SPECIAL CAP MEETING – 19 JUNE 2024
ITEM 11.1

DEVELOPMENT NO.:	21031284
APPLICANT:	PC Infrastructure Pty Ltd
ADDRESS:	160 LONGWOOD RD HEATHFIELD SA 5153 CT 6003/528
NATURE OF DEVELOPMENT:	24 hour retail fuel outlet with associated canopy, car cleaning & dog wash facilities, 70,000L underground fuel storage tank, pylon advertising sign (maximum height 7m), combined fence & retaining walls, retaining walls, car parking & landscaping (Amended Proposal)
ZONING INFORMATION:	Zones: <ul style="list-style-type: none"> • Rural Neighbourhood Subzones: <ul style="list-style-type: none"> • Adelaide Hills Overlays: <ul style="list-style-type: none"> • Hazards (Bushfire - High Risk) • Hazards (Flooding - Evidence Required) • Mount Lofty Ranges Water Supply Catchment (Area 2) • Native Vegetation • Prescribed Wells Area • Regulated and Significant Tree
LODGEMENT DATE:	1 February 2022
RELEVANT AUTHORITY:	Assessment Panel at Adelaide Hills Council
PLANNING & DESIGN CODE VERSION:	2022.1

DETAILED DESCRIPTION OF COMPROMISE PROPOSAL:

Location of manual car wash on previously refused proposal

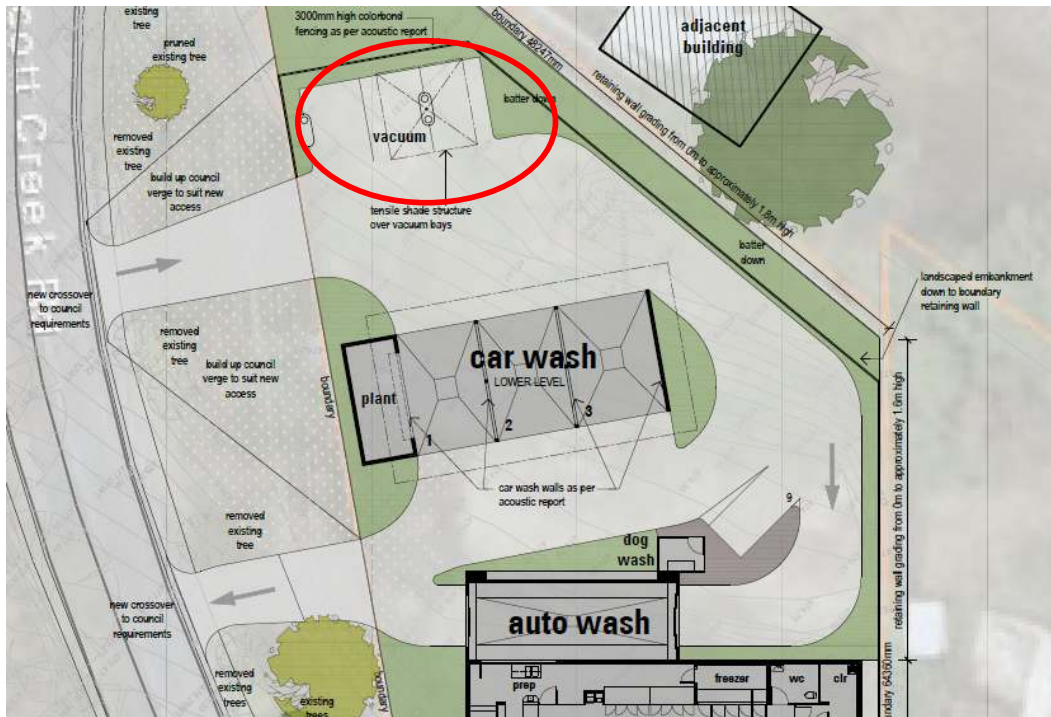
1. Removal of the manual car wash and plant room;

Removal of manual car wash on compromise proposal

Location of vacuum bays on previously refused proposal

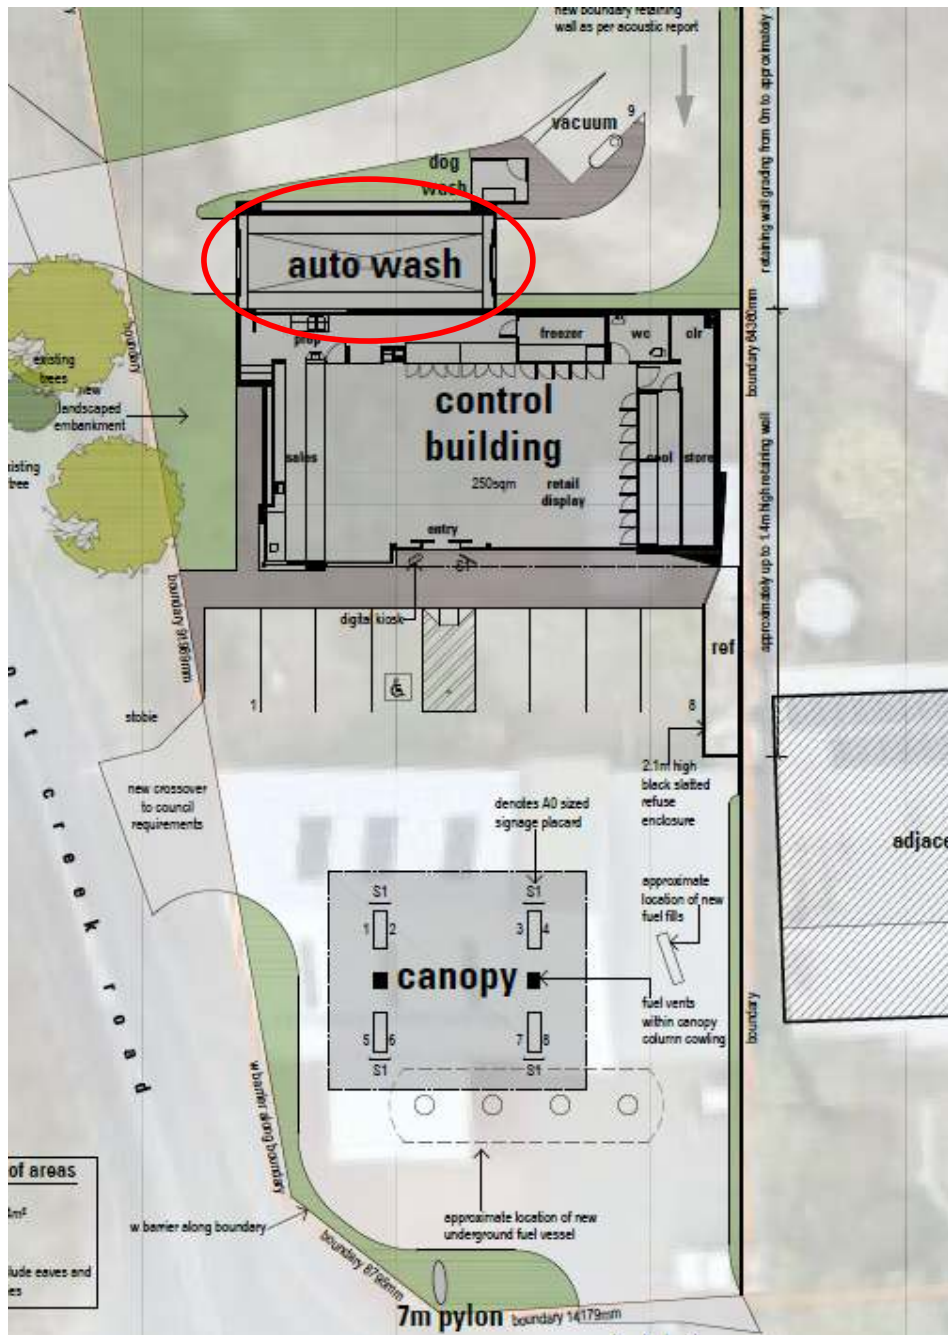
- 2. A reduction of vacuum bays from three to one and relocation of the vacuum bay adjacent to the automatic car wash;

Relocated vacuum bay on compromise proposal

Area of acoustic fence which is proposed to be removed

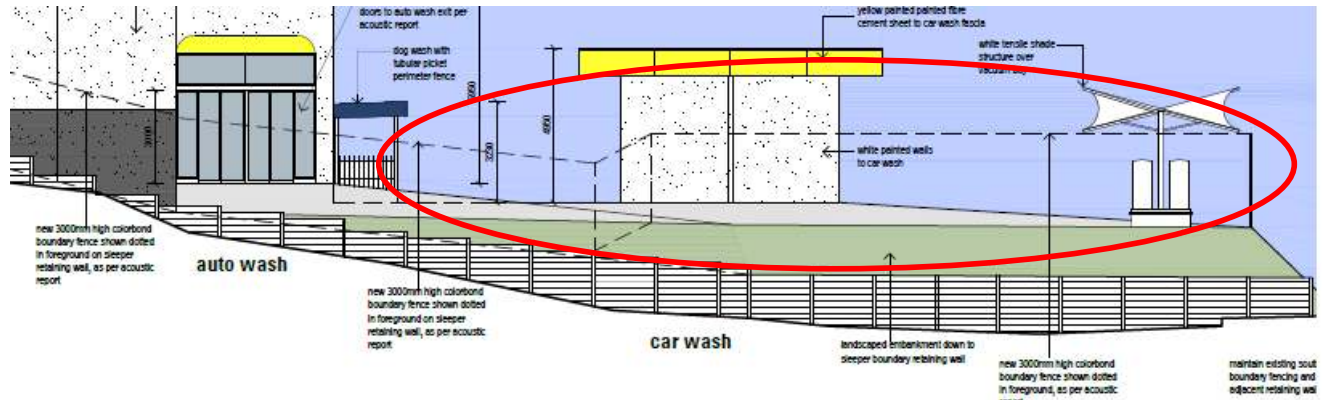
- 5. Removal of a three metre high acoustic fence adjacent the southern and south-western boundary; and addition of 1.8m high fence on top of retaining wall (maximum height 1.8m).

Location of three metre high acoustic fence on western boundary on previously refused proposal

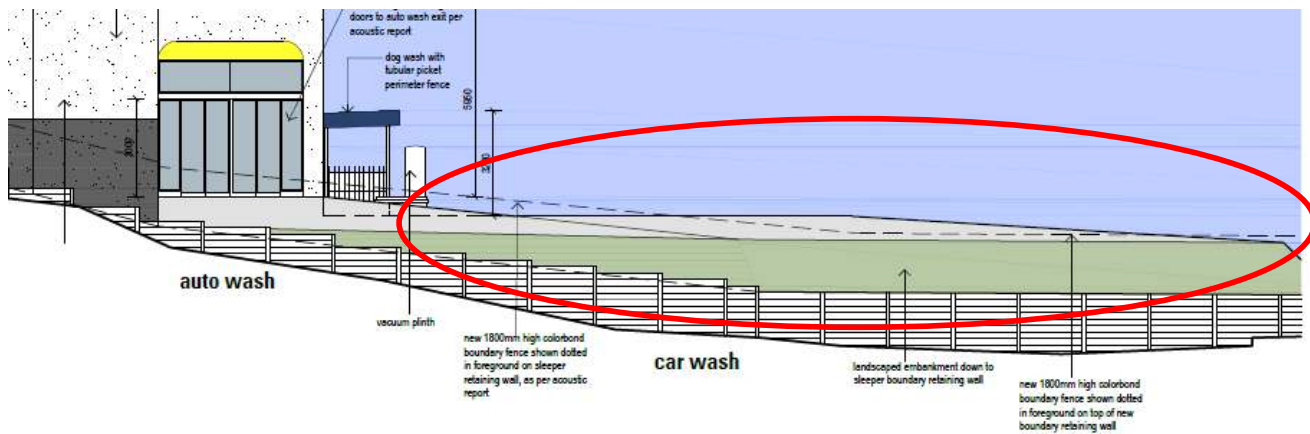
- Reduction of the three metre high acoustic fence to 1.8m on the western boundary; except in the location forward of the control building where portion of the fence will transition in height from 3m to 1.8m on top of retaining walls.

New 1.8m high colorbond fence on western boundary on compromise plans
